Access Compliance Report

Public Rights-of-Way

Intersection ID: 14278	Main Street: ROMARE_BEARDEN_DR	Cross Street: FARMER_ST	Location: NE
ADA ID: 5B3091F9CA24	Ramp Type: Perp	Initial Pass/Fail: Fail	Overall Compliance: No
Severity Score: 1.25			
Codes/Mitigation Info/Possible Solution		Field Measurements/Component Compliance

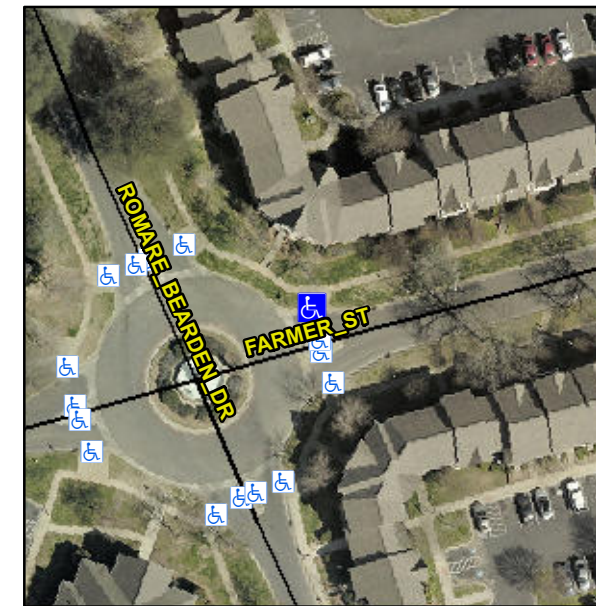
R304.5.3

Compliance	Description	Data	Compliance	Description	Data
N/A	Ramp Length (in)	97.0	Yes	Ramp Slope (%)	7.1
Yes	Ramp Width (in)	60.0	No	Ramp XSlope (%)	4.1
N/A	Flare Type LT	N/A	N/A	Flare Type RT	N/A
N/A	Flare Slope LT (%)	N/A	N/A	Flare Slope RT (%)	N/A
N/A	Flare Traversable LT?	N/A	N/A	Flare Traversable RT?	N/A
N/A	Landing Length (in)	N/A	N/A	DWS Provided?	N/A
N/A	Landing Width (in)	N/A	N/A	DWS Contrast?	N/A
N/A	Landing Slope (%)	N/A	N/A	DWS Length (in)	N/A
N/A	Landing X Slope (%)	N/A	N/A	DWS Full Width?	N/A
N/A	Landing Curb? (Y/N)	N/A	N/A	DWS Offset (in)	N/A
N/A	Shared Landing?	N/A			
N/A	Gutter Ponding?	N/A	N/A	Gutter Slope (%)	N/A
N/A	Gutter Lip Ht (in)	N/A	N/A	Gutter X Slope (%)	N/A
N/A	Painted X Walk1?	No	N/A	Painted X Walk2?	N/A
	X Walk 1 Direction	To S		X Walk 2 Direction	N/A
N/A	X Walk 1 Width (in)	N/A	N/A	X Walk 2 Width (in)	N/A
	X Walk 1 Slope (%)	0.4		X Walk 2 Slope (%)	N/A
	X Walk 1 X Slope (%)	2.9		X Walk 2 X Slope (%)	N/A

Remove & Replace Entire Ramp.
